M9537A-04

Modification Recommended Service Note

M9537A AXIe High Performance Embedded Controller

Intel Active Management Technology Escalation of Privilege

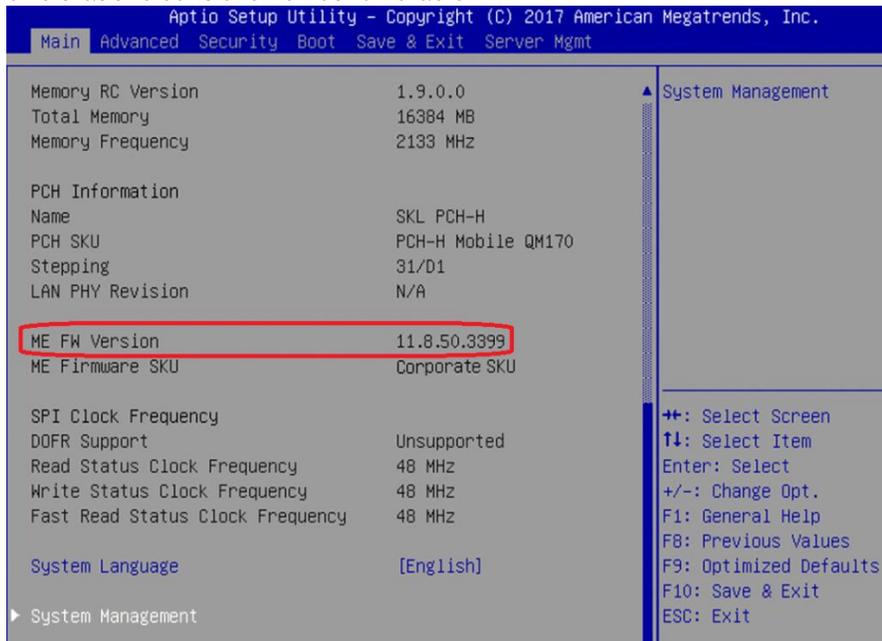
1. Power on or reboot your embedded controller.
2. Press the <Delete> key when the controller beeps. This should be concurrent with the main startup screen. The BIOS setup program loads after a short delay.
3. At the BIOS Main Setup screen, verify that the “ME FW Version” is version 11.8.50.3399 or later. Below picture shows that this controller is not vulnerable.

Option 1: Update the BIOS to version SL06 or later by following the instructions at [M9537A BIOS Downloads](#).

Option 2: Refer to the [Intel SA-00086](#) for the steps to mitigate.
